Seismic Walkdown Checklist (SWC)

Equipment ID No. Q2H21E505 Equip. Class¹ 20

Equipment Description 4.16KV SWITCHGEAR 2J LOCAL CONT PANEL

Equipment ID No. Q2H21E505 Equip. Class' 20

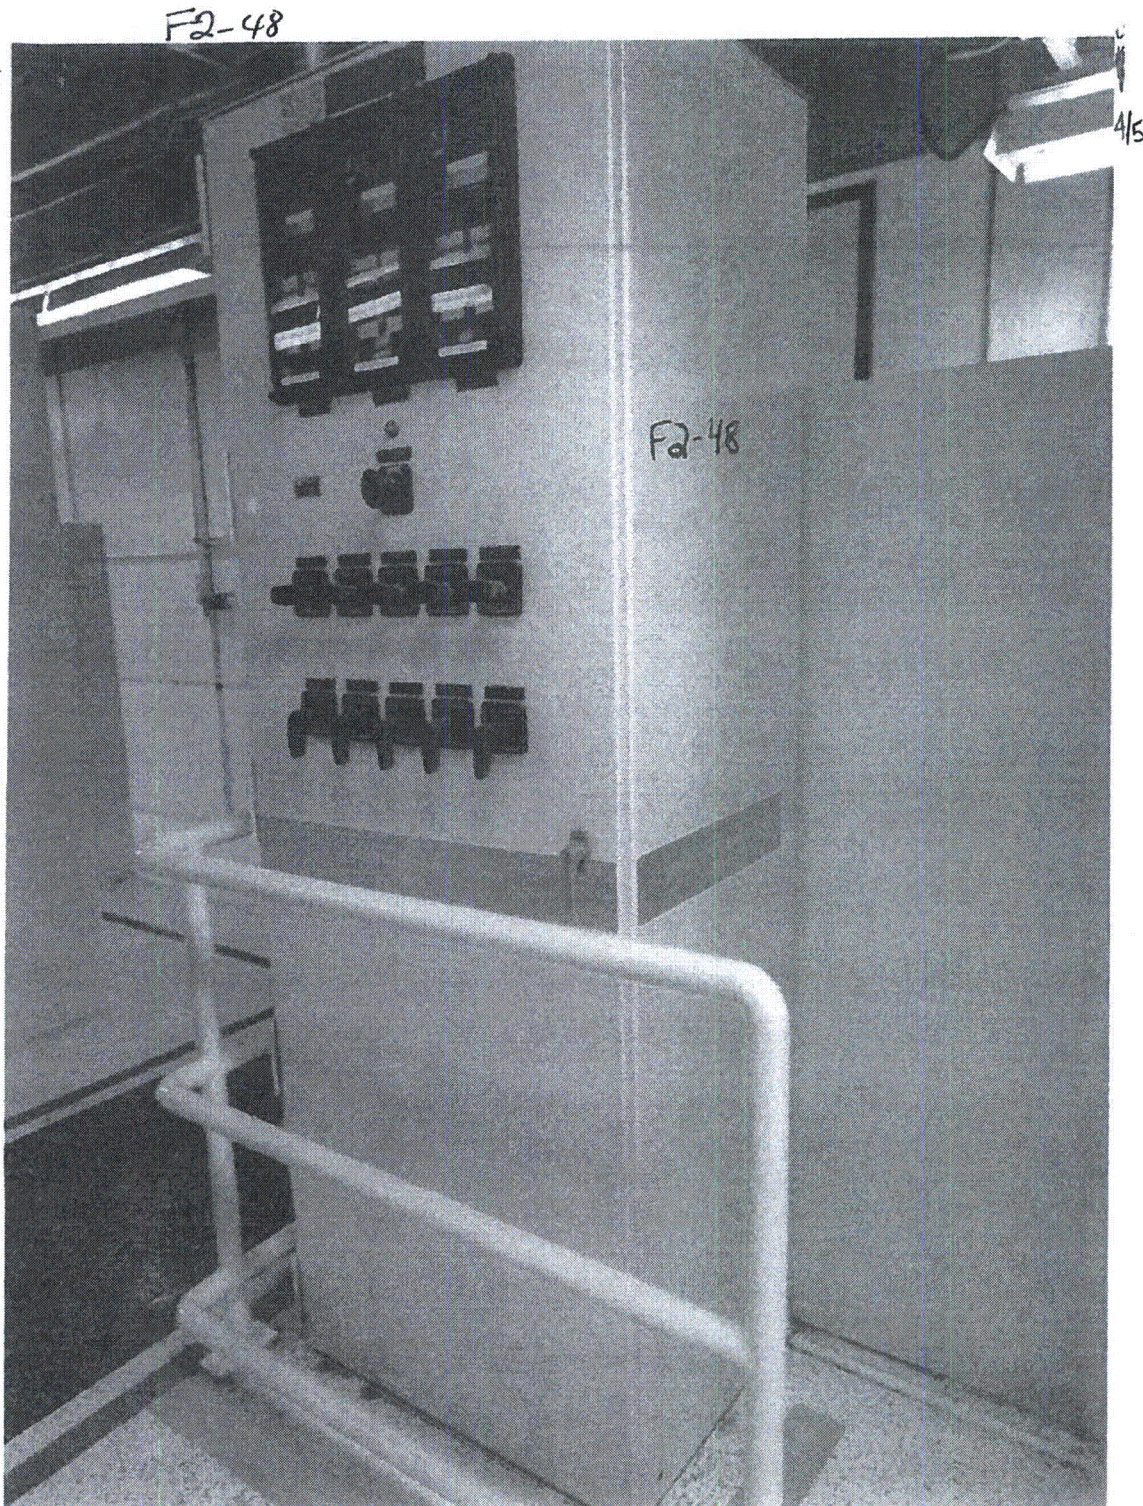
7. Are soft targets free from impact by nearby equipment or structures? YES NO U N/A
 1" gap b/t panel Q2H21E505 and U-2 4160 Bus 2J. Per Calculation SC 85-1-3347-001
 the panel is bolted at the four corners and is rigid with negligible deflections.
 The panel Q2H21E505 is also rigidly mounted with rigid conduit at the top. Therefore, 1" gap is acceptable.

Equipment ID No: Q2H21E507 Equip. Class: 20

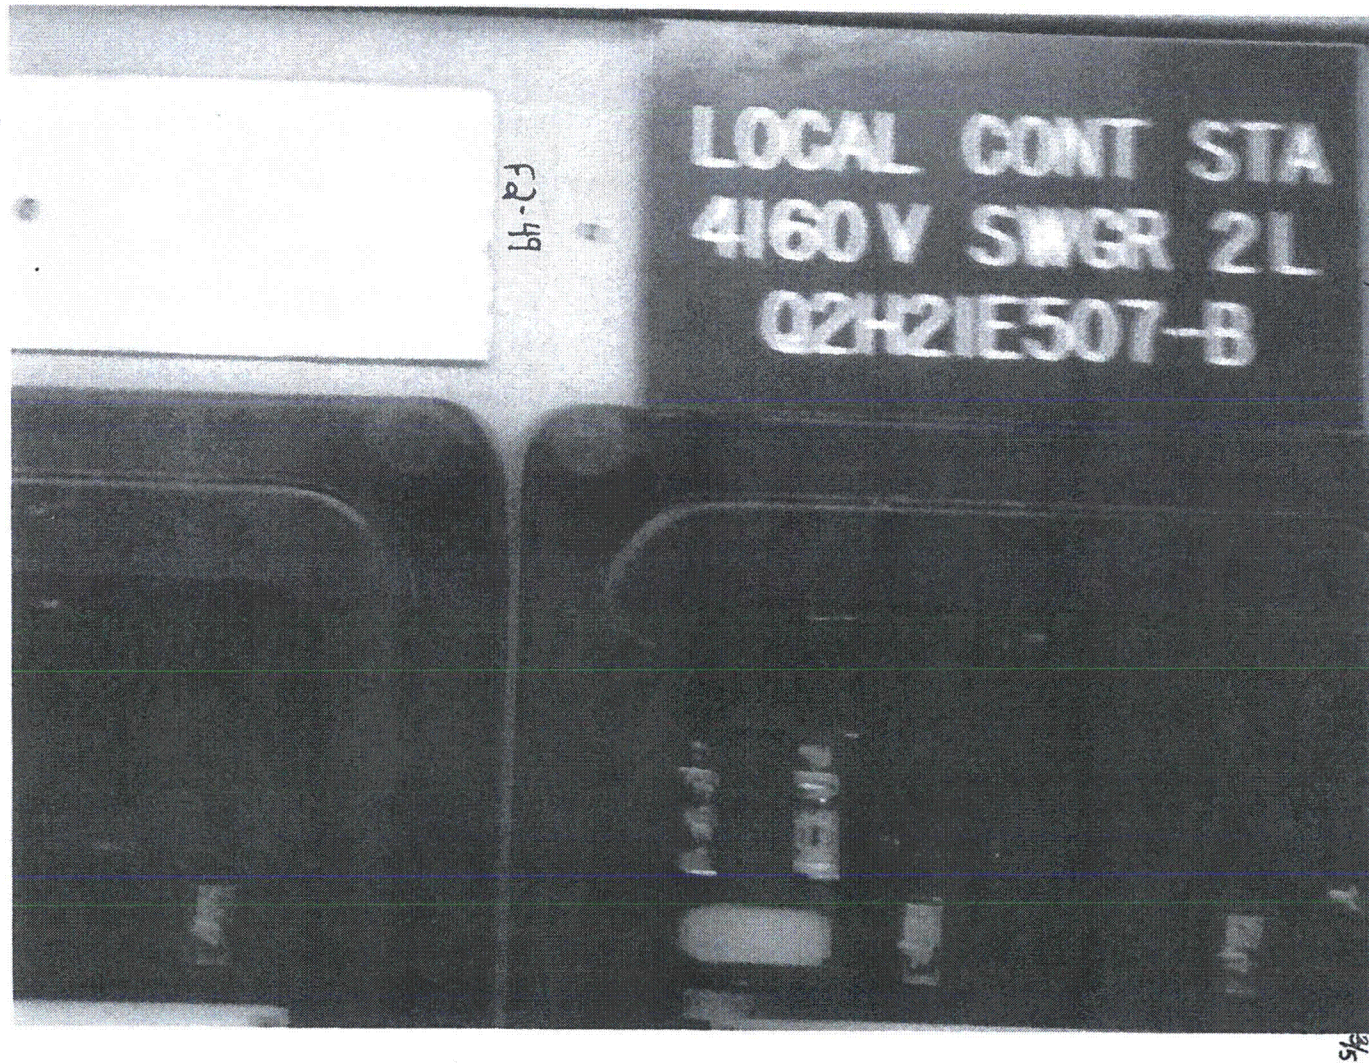
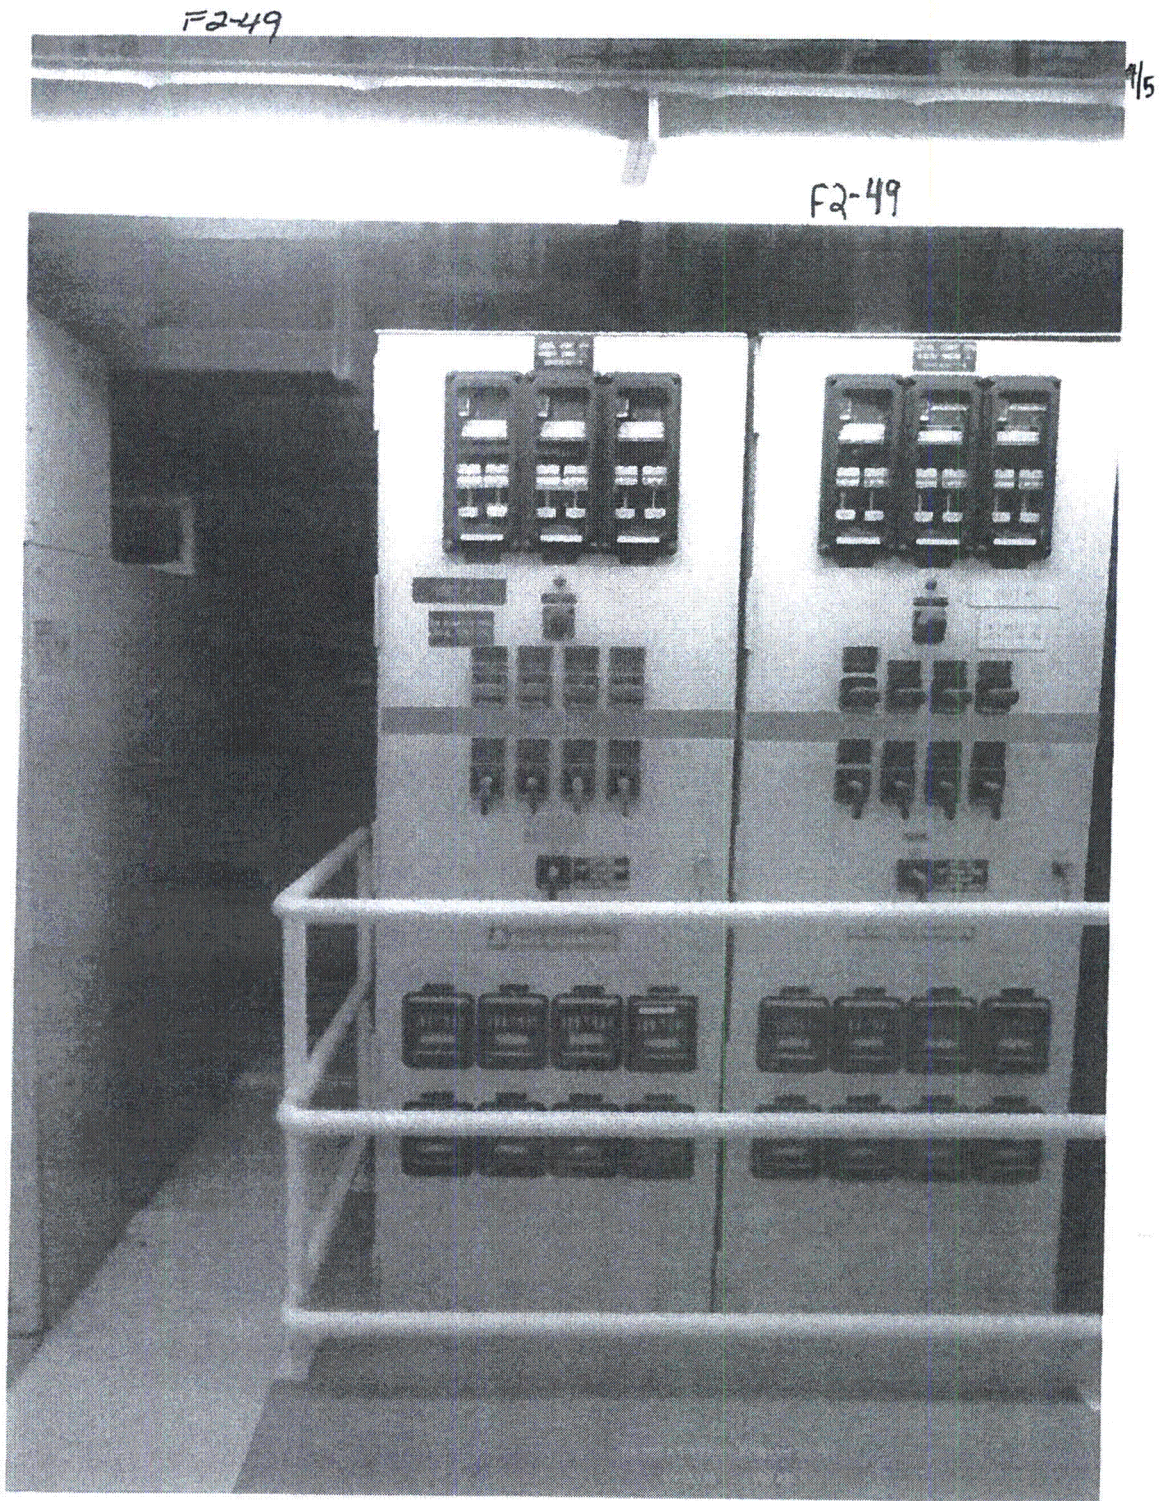
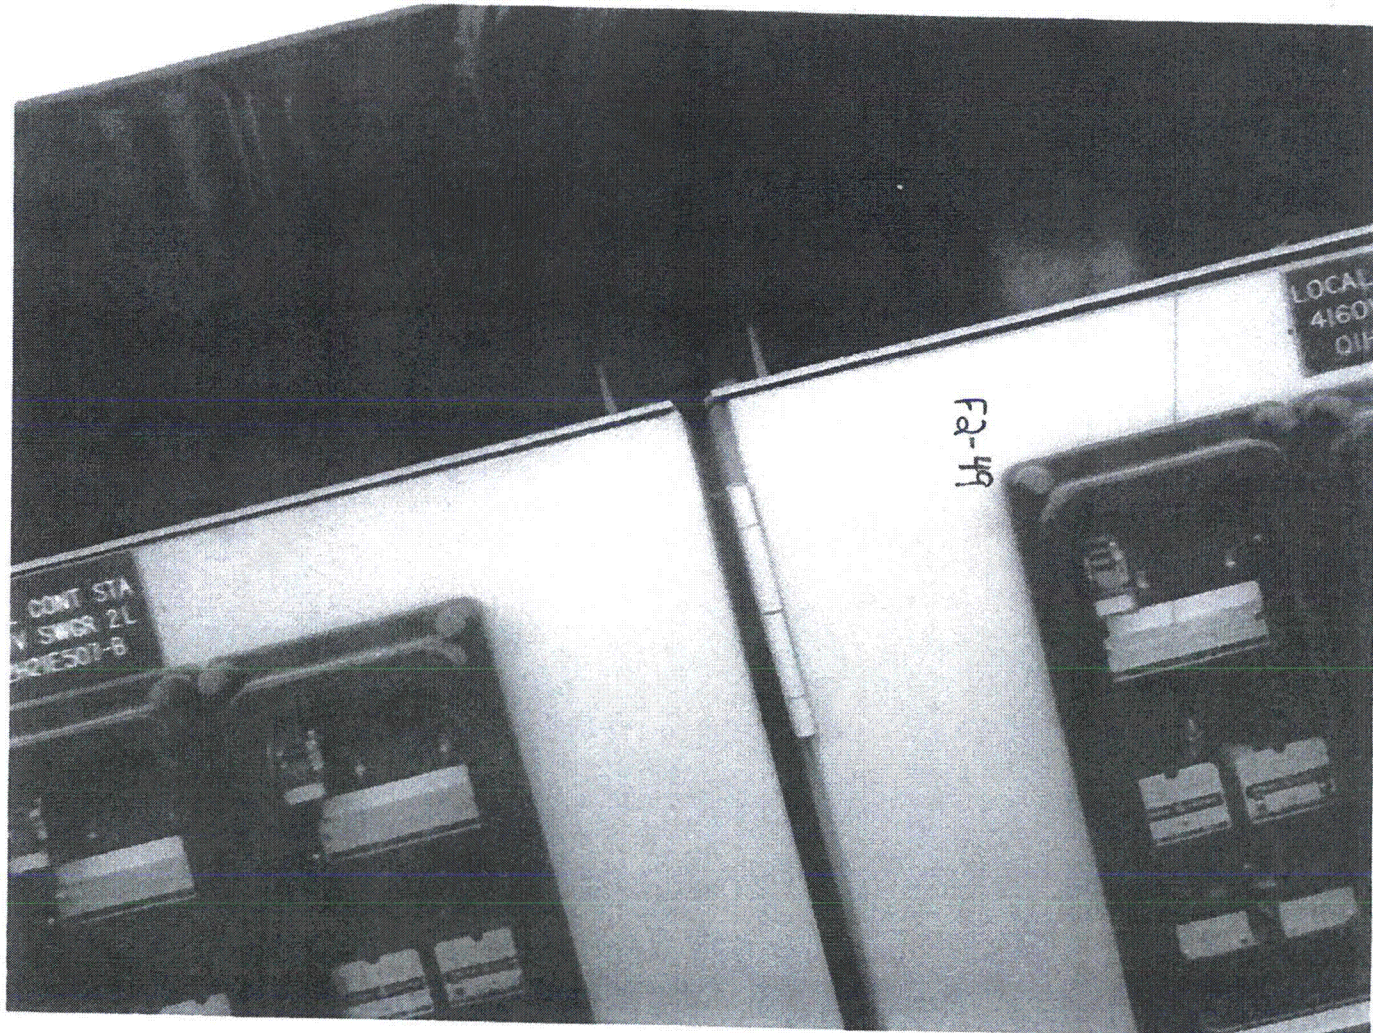
IPEE: overhead light interaction, adjacent cabinets not bolted together, lighting is ^{now} restrained with wire ties and cabinets are bolted together at the top of panels.
 Interior mounting bolts could not be confirmed as cabinet could not be opened.
